STAFF REPORT

REFERENCES: RM080597

SUBJECT: **B LEIGH - REPORT EP09/03/06** - Report prepared for hearing of 30 March 2009

PROPOSAL: Section 357 objection to Conditions 6 and 11 of Resource Consent RM080597. The applicant also seeks clarification regarding Conditions 6(d) and 10.

PLAN 'A'

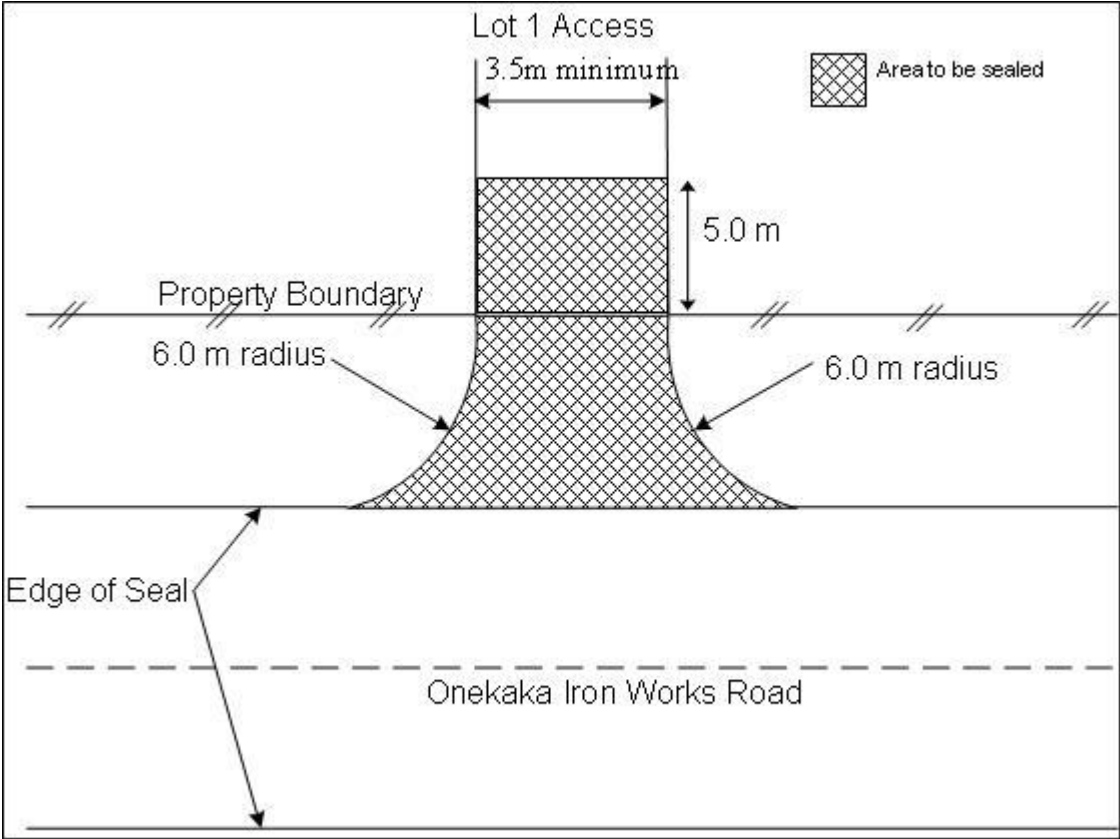
Condition 6(a) and 6(c) require the upgrading of Ironworks Road to a 5.0m sealed carriageway and 2 x 600mm berms, plus a 1.4m wide sealed footpath.

Relief Sought: *The applicant acknowledges that some form of contribution is fair and is prepared to widen the carriageway to a 5.0m wide metal (formation) with 0.6m wide berms and enhance sight distances in line with the requirements of RM050663.*

Iron Works Road outside the applicant's frontage remains as a 3.4 metre wide gravel surface and it is only fair that an upgrade is required when new traffic is generated. In theory the east side of the road has been developed (subdivided) to the limits set out in the TRMP and the applicant's side (7.8 hectares) is the only title left that can be subdivided as a controlled activity. If this was not the case then perhaps a further contribution could have been requested for the eastern side when it is developed. Council has, by way of the applicant's subdivision, only requested the upgrade along the frontage of Lot 1, rather than the entire 7.8 hectare property frontage as the footpath is on that side of the road. It is only fair that the applicant form the road for a length of 50 metres and construct the new footpath and that this is consistent with the requirements for the previous nine lot subdivision (RM050700).

- a) That Condition 6 remains unchanged and that the full upgrade be required.
- b) That Condition 11 have an **Advice Note** attached stating that as an engineering report prepared by Bill Page has already been submitted to Council as part of the application, all that remains to comply with this Condition is the provision of a Certificate in accordance with NZS:4404, Schedule 2A. Council will accept this certificate being prepared by a Chartered Professional Engineer practicing in civil engineering.
- c) That a new Condition 6A be included within the consent to confirm the need for Engineering Plans for the road upgrading works along the frontage of Lot 1. The wording for Condition 6A is as follows:
